## City of Sedona Planning and Zoning Commission Meeting

# Staff Report

PZ21-00006 (ZC, DEV) Archer Hotel  
Summary Sheet: Conceptual Review

**Action Requested:** Conceptual Review of Zone Change and Development Review Application

SHEET TITLE:  
 EXISTING TOPOGRAPHY  
 WITH ROOF HEIGHTS

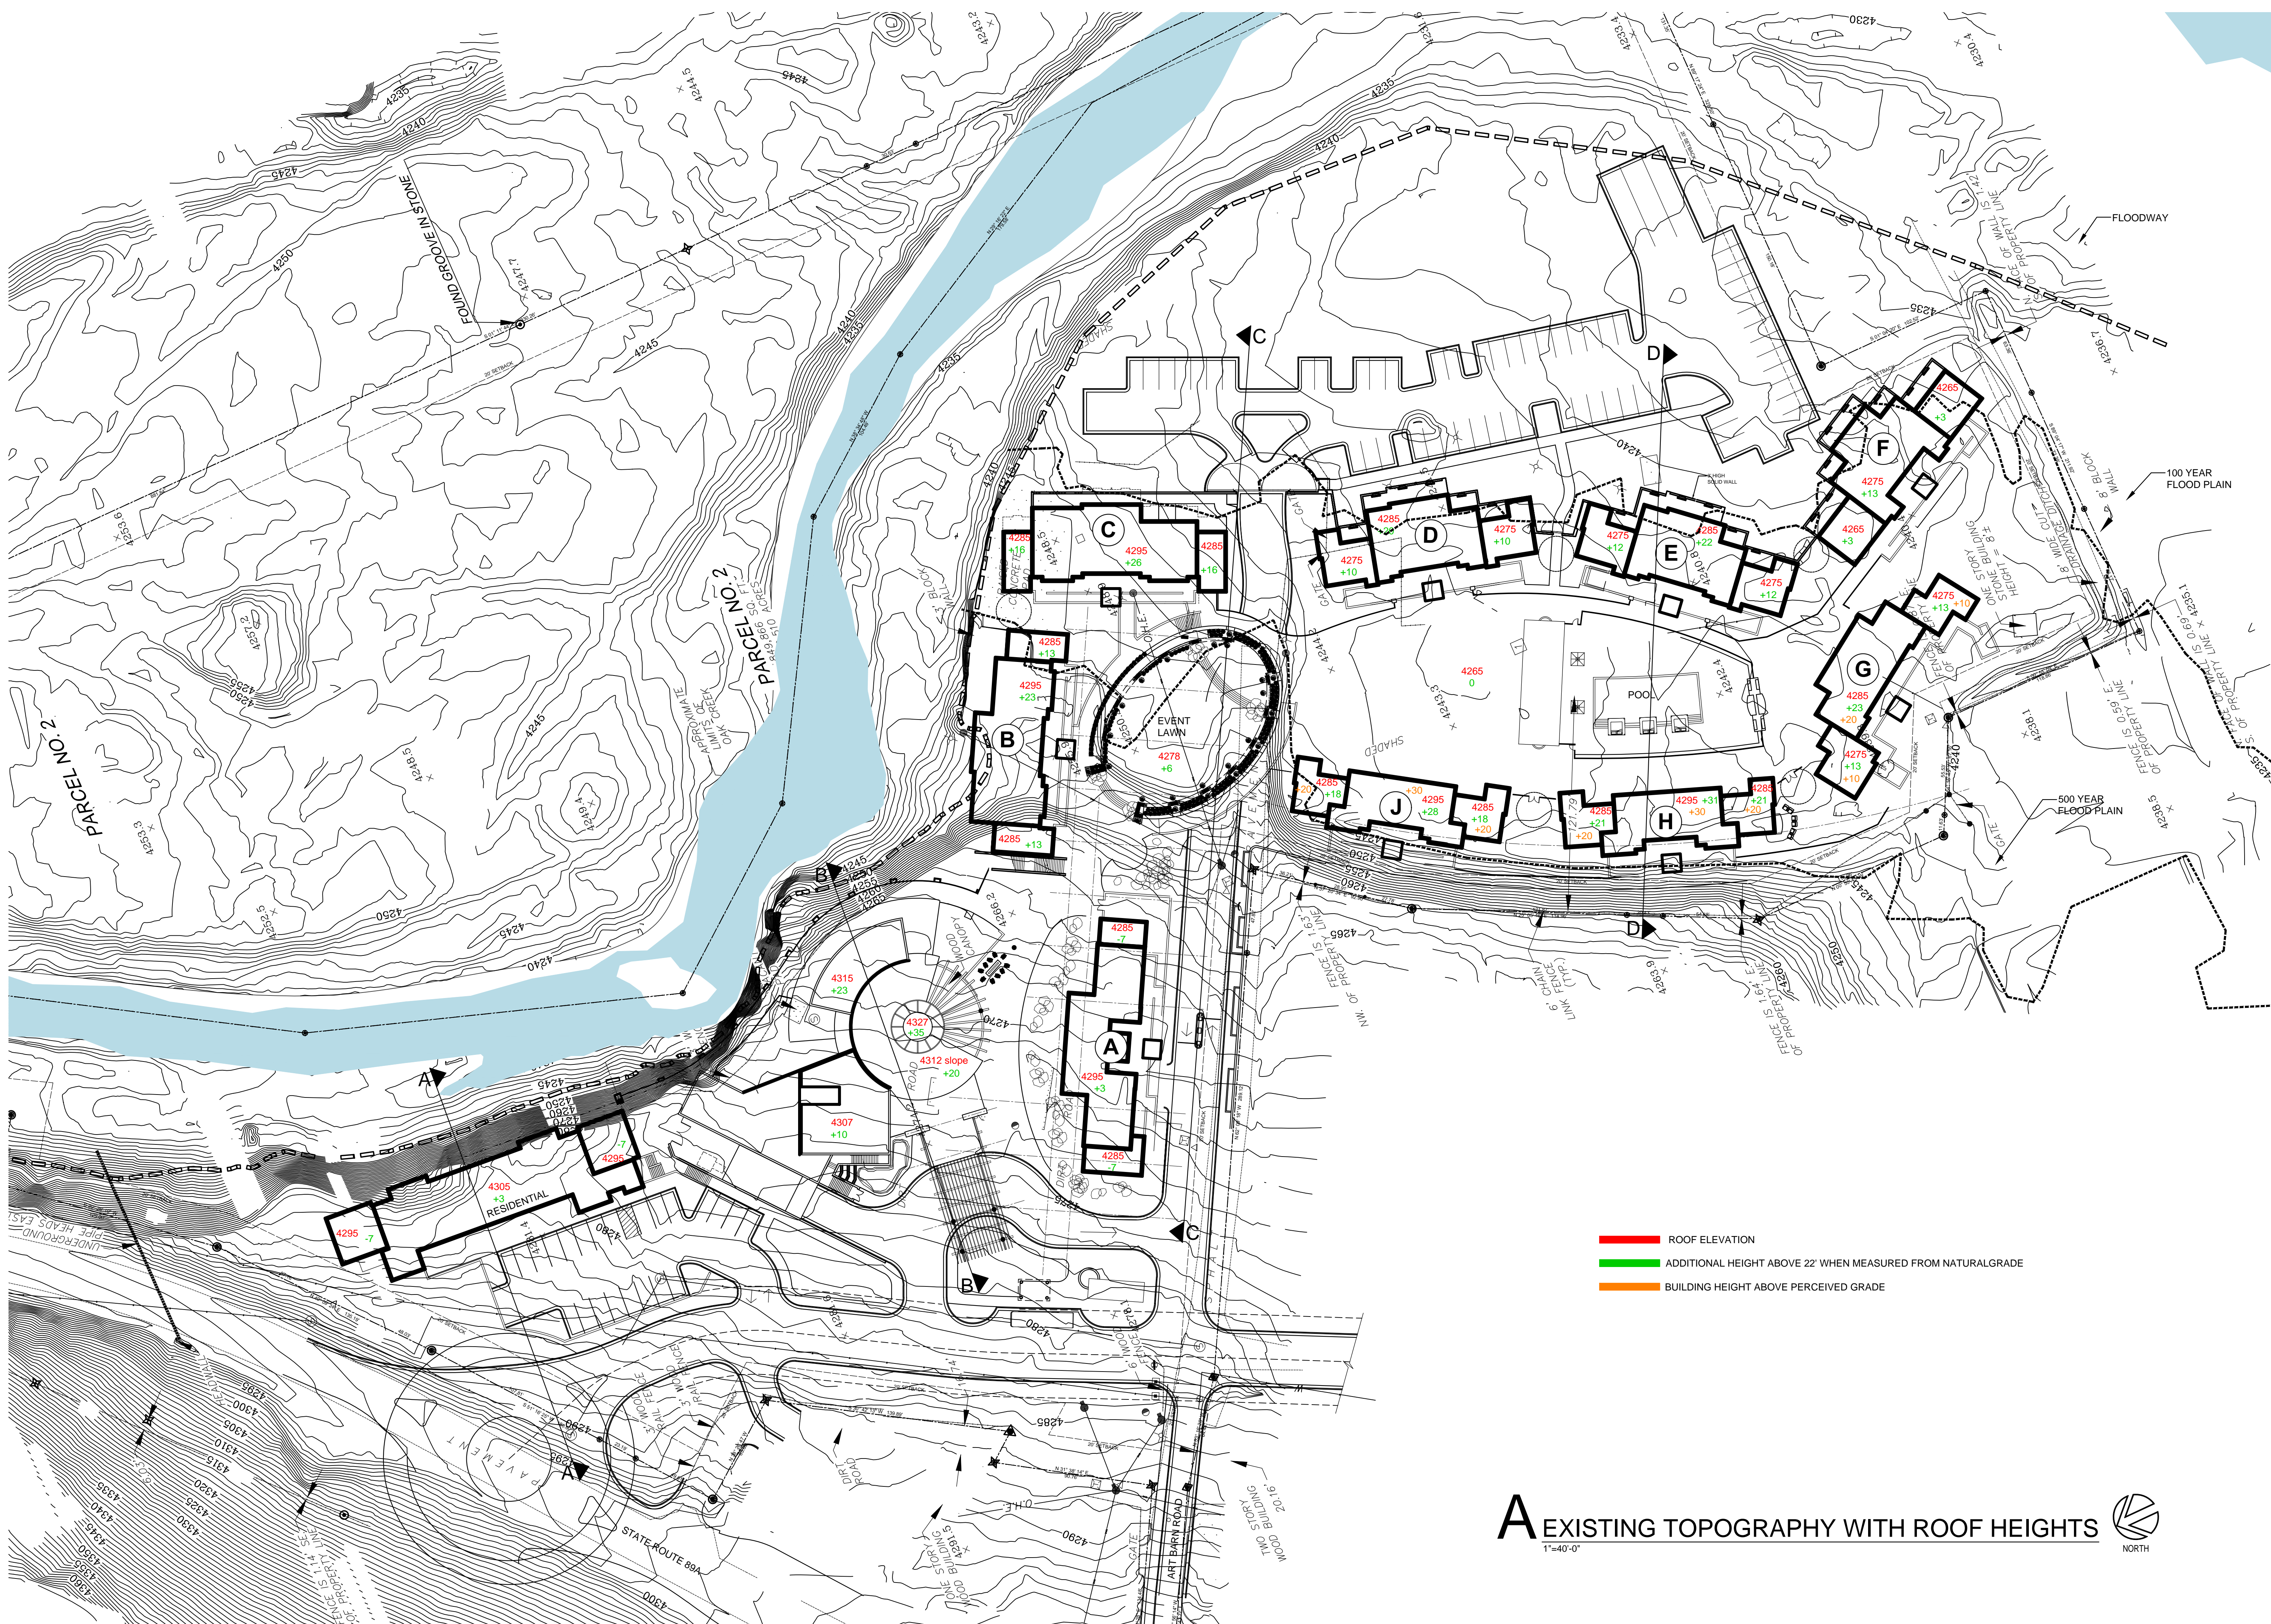
- *These maximum heights should be equivalent to heights that would be permitted along shared property lines without the requests for increases in height. The plans submitted by the applicant show significant height increases at property lines.*

- *The applicant provided plans to Staff address some of these questions. These plans show significant height increases on nearly all of the buildings, with the largest height increases proposed on the buildings located closest to adjacent properties. While height increases may be considered, Staff has concerns with the way the heights are currently being shown:*
  - *Building heights along the property lines that impact adjacent properties should adhere to established height limits.*
  - *The greatest height allowances should be proposed in areas furthest from other properties.*
  - *Additional buildings heights should be considered for provision of community benefits identified in the Draft CFA, such as additional housing or keeping development and/or parking out of the floodplain.*
  - *See additional comments under the CFA section of this Staff Report.*
